Title: Communication Overhead Description Schema for Multi Core Processor in Model-based

Authors: Yue Hou, Yutaro Kobayashi, Hiroshi Fujimoto, and Takuya Azumi

## 1 Response to Meta-reviewer

Fig.1 System model.

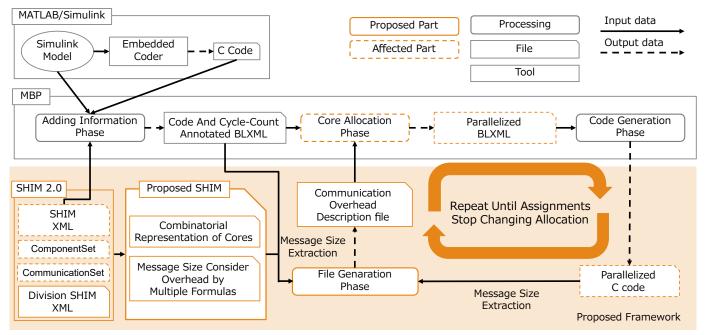
I wonder why the Parts for ComponentSet and CommunicationSet, which could be seen in the title of the sub-sub-section, did not appear in Figure 1 as seen in the title of the other sub-sub-section.

Thank you for your insightful comments and suggestions regarding our manuscript. In response to the review, we have updated Figure 1 to include the parts for ComponentSet and CommunicationSet. We also made minor modifications to the original system model and have clarified once again that our proposal builds upon the existing SHIM framework. We appreciate your insightful comments which have guided these enhancements. Thank you for helping us improve our work.
